NACELLE - POWERPLANT - LATCH BRACKET, NO. 1, LOWER, THRUST REVERSER - REPLACEMENT OF

V2500-D5

78-00-00

V2500-NAC-78-0157
Page 1 of 8

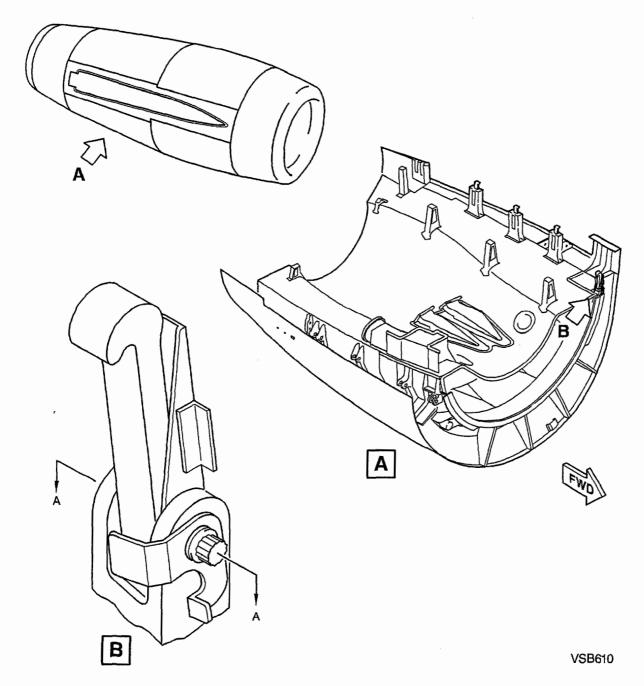
- B. Remove nut, bolt, washers, 290-0287-503 bushings, and the 290-0281-507 (290-0287-508) bracket. Discard the bushings and the bracket. Refer to Figure 1.

Lower Thrust Reverser No. 1 Latch Bracket Replacement Figure 1 (Sheet 1)

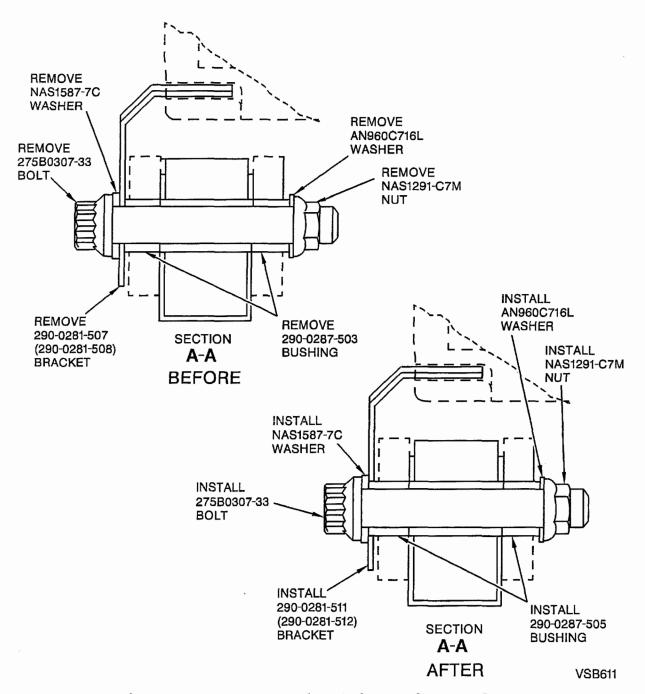
- C. Install the 290-0281-511 (290-0281-512) bracket, 290-0287-505 bushings, the washers, bolt, and the nut. Torque the nut to 450-500 lbin (50.8-56.5 Nm). Refer to Figure 2.
